PROPOSALS FOR A NEW MOTORWAY REST AREA ON LAND AT JUNCTION 16 OF THE M4, WILTSHIRE - RESPONSE TO SWINDON COUNCIL COMMENTS

APPLICATION REF: PL/2023/09142 – July 2024 (3728)

This note will set out a consideration of Swindon Borough Council's (SBC) formal consultation response dated 30th November 2023. The SBC comments are provided in **Appendix 1**.

APPENDIX 2

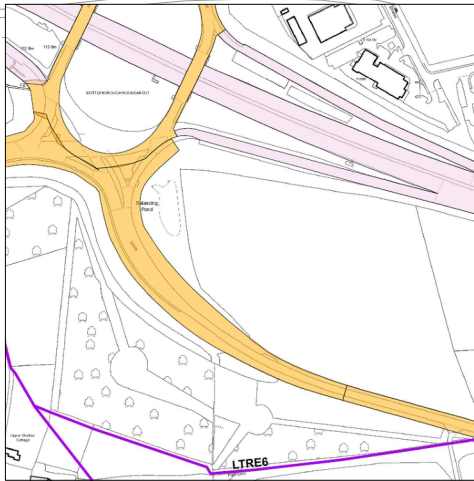
SBC stated they are unsure of the differences between an MSA and an MRA. Annex A of Circular 01/2022 sets out those differences as well as the minimum facility requirements for each facility. The facilities proposed align with an MRA.

One difference between an MRA and an MSA is National Highways prescribed signage policy from the motorway network. MRA signage is much simpler and therefore results in a lower trip attraction for vehicles travelling on the mainline. **Appendix 2** shows the prescribed signage journey of an MSA in comparison to an MRA. As can be seen, the allowed signage, which is the primary turn-in generator is significantly reduced for an MRA in comparison to an MSA. This results in lower turn-in rates as set out in the DfT Circular.

DRAWING NUMBER:	3728-F06	REVISION:	C
-----------------	----------	-----------	---

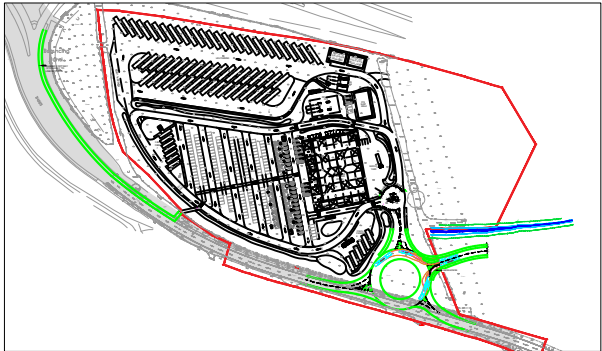
However, SBC have stated that they require a new footway along the southern boundary of the site to ensure a direct connection between the site and the existing footway network to the north of the site. This will be provided by the applicant and is shown **Drawing Number 3728-F06 Revision C**, appended to this note.

I accept that the proposed facility is intended to offer services to drivers and that accessibility by non-car modes is limited to those who work at the site. That does not however mean that the needs of those who are reliant on travelling to the site on foot, by bicycle and by public transport can be ignored. The TA, at section 5.2, identifies the need to supplement the existing pedestrian infrastructure to provide a continuous route to the application site. It is stated (para 5.2.3) that the applicant is *'content to explore'* the provision of the missing footway that is identified by the applicant's Transport Consultant. I suggest that the applicant should be obliged to deliver this piece of infrastructure.
